City of Florence
Planning Commission Meeting Minutes
250 Hwy 101, Florence, OR 97439
August 23, 2022

4. RESOLUTION PC 22 05 DR 04 & SR 22 11 SIR 06 – Quince Street Wyndham Microtel Design Review and Phase 1 Site Investigation Report

Quince St. Hospitality, LLC Microtel

**PC 22 05 DR 04 & AR 22
11 SIR 06**

Yellow Recesses & Trim

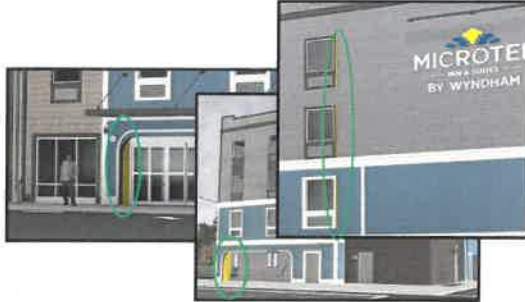
Comm Murphey asked about the Coastal Color Palette, he said that the palette is in words only and that the City does not have color chart that tells what colors are included in this palette. He questioned the branded yellow.

Comm Tarvin: a clarification on the yellow color are the trims on the windows and fins an accent for your logo or will all the window be trimmed in yellow?

1. Sign and design review regulations do not regulate the color of signage and so is not a decision point. 10-6-6-4.G-2 permits deviation to color regulations via an adjustment. The proposal includes façade alcoves with a yellow branding component.

Michael Parshall, the yellow will only be on the 3 windows it is the furthest South 3 windows, closest to the microtel signage, we are envisioning them to be a protruding aluminum or metal fin, just to incorporate a very subtle way to incorporate the brand color.

An adjustment is allowed through review of the Planning Commission and as part of this Design Review approval process. Should the Planning Commission disapprove the proposed yellow in the alcoves/inset areas and/or yellow window trim which appear to be visible from Quince St., the applicant shall propose an alternate color as required in FCC 10-6-6-4 G. [Supplemental Condition tbd]

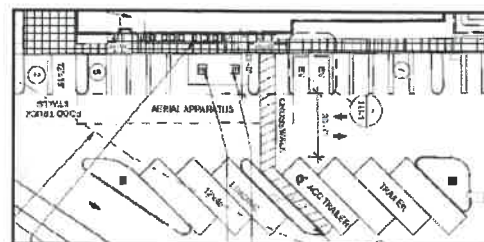
4.4. Per FCC 10-3-10 (H), the applicant's proposed bicycle parking plan shall demonstrate that such parking will not impede nor create any pedestrian hazards. Prior to issuance of final Certificate of Occupancy, applicant shall provide evidence to the Planning Department that the bicycle parking area will meet the requirements of FCC 10-3-10 (H).

4.4. continued. Plans provided did not give dimensions in the bike rack area for staff to determine if FCC 10-3-10 H was met. Revising the original proposed condition will ensure applicant will not need to go through an additional Design Review process.

Special Development Standards

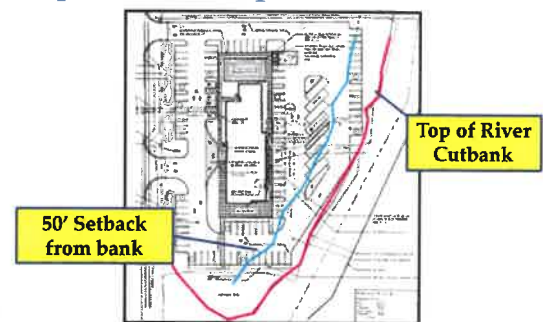
6. Demonstrate bank can withstand building and parking area build through engineered plans.

6.1 An underlying need to protect the slope is the retention of natural landscaping. Any future proposal involving the removal of these critical plants shall require a Type II Vegetation Clearing Permit application to ensure protection of the bank. Correct Condition number to reflect "6.1, not "6.2" on page 42 of Exhibit A.

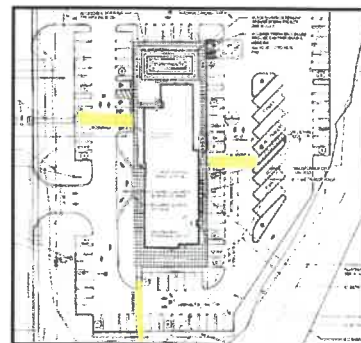
10.4. The applicant shall demonstrate adequate turn radius distances to the Fire Marshal under applicable Fire Code Standards, that fire apertures can safely access the site. Both Exhibit A (p. 76) & Resolution PC 22 05 DR 04 and AR 22 11 SIR 06 need to be amended to reflect changes to this condition.

10.6. Pedestrian crossings exceed distance requirements of 24'. Mark with contrasting materials unless Planning Commission approves proposal. Discussion point # 1 of AIS

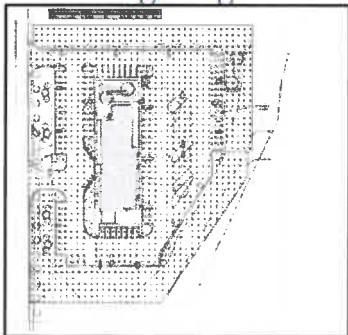
- 12. Per FCC 10-37-4 B, the applicant shall ensure that parking areas have lighting to provide at least two (2) footcandles of illumination at any point in the entire lot with a maximum of five (5) foot-candles over parking spaces and walkways. The condition number and the reference to "FCC" will be added to p. 92 of the approved Findings (Exhibit A) and Resolution PC 22 05 DR 04 and AR 22 11 SR 06.

Discussion point # 4 of AIS

- 12.1 If Planning Commission does not approve lighting plan, applicant to resubmit.
